SAFETY RECALL

SR22-05C

DATE :	September 2022	SECTION: 06 ELECTRICAL
SUBJECT:	ALTERNATO	R BELTS REPLACEMENT

Aramid reinforced cord belt (left) vs new polyester cord belt (right).

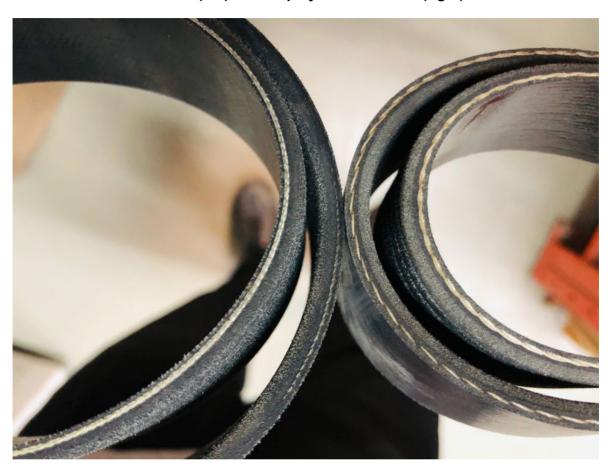
On vehicles affected by this recall, the heavy duty alternator belt (with aramid cord reinforcement) may continue to turn the alternator pulley after an alternator bearing failure. If the pulley continues to turn, it could lead to front bearing overheat.

Therefore, the heavy duty aramid belts must be replaced by polyester belts as needed following the interchange table provided.

- 7. Inspect the alternator belt(s) (refer to the picture above).
  - If the belts are polyester reinforced reinstall them.
  - If the belts are reinforced with aramid cords, complete the inspection and replace them with new polyester belts (see interchange table).
- 8. Reverse the procedure to reinstall the other belts on the vehicle.
